**SOLICITATION AMENDMENT
MODIFICATION DE L'INVITATION**

Title - Sujet Supply Prefabricated Building Mater	
Solicitation No. - N° de l'invitation 21C42-180323/A	Amendment No. - N° modif. 001
Client Reference No. - N° de référence du client 21C42-18-0323	Date 2018-01-22
GETS Reference No. - N° de référence de SEAG PW-\$KIN-519-7398	
File No. - N° de dossier KIN-7-48198 (519)	CCC No./N° CCC - FMS No./N° VME
Solicitation Closes - L'invitation prend fin at - à 02:00 PM on - le 2018-01-31	
Time Zone Fuseau horaire Eastern Standard Time EST	
F.O.B. - F.A.B. Plant-Usine: <input type="checkbox"/> Destination: <input checked="" type="checkbox"/> Other-Autre: <input type="checkbox"/>	
Address Enquiries to: - Adresser toutes questions à: Choquette, Herb	Buyer Id - Id de l'acheteur kin519
Telephone No. - N° de téléphone (613) 536-4874 ()	FAX No. - N° de FAX (613) 545-8067
Destination - of Goods, Services, and Construction: Destination - des biens, services et construction:

This amendment is being issued in response to Bidder's questions and Canada's responses.

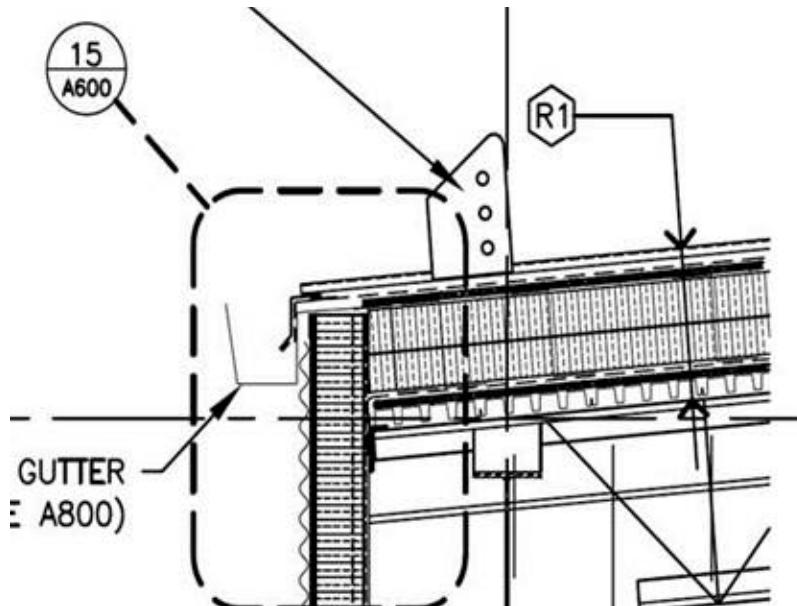
Q3. I was wondering if you could clarify what you're looking for with the 12"x12" (90 degree angle) sheet metal closures my sales rep is unsure as to what you want regarding these.

A3. We have attached a photo of where this sheet metal is on the drawing to help clarify
